PRODUCT CHANGE NOTIFICATION

Bourns® Model SRU1063A Series & Model SRU1063-220Y Shielded Power Inductors

Manufacturing Site Relocation, Process Automation, and Gluing Method Change

IC24134

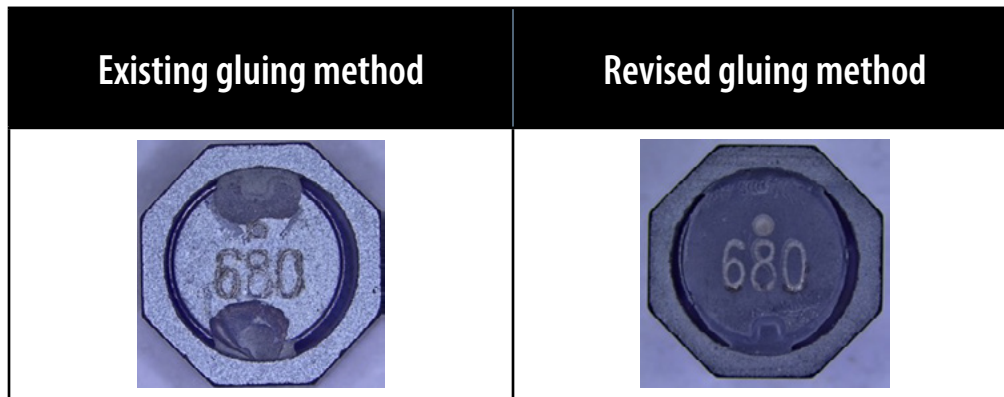
Bourns will also change its gluing, marking, testing, and packaging processes to a single automated process. Additionally, the gluing method will be changed for some models of the [SRU1063A](#) series. The modified gluing method will have a larger application area. A list of affected part numbers is included below.

Affected Part Numbers – Gluing Method Change		
SRU1063A-4R7Y	SRU1063A-150Y	SRU1063A-470Y
SRU1063A-6R8Y	SRU1063A-220Y	SRU1063A-680Y
SRU1063A-100Y	SRU1063A-330Y	SRU1063A-101Y
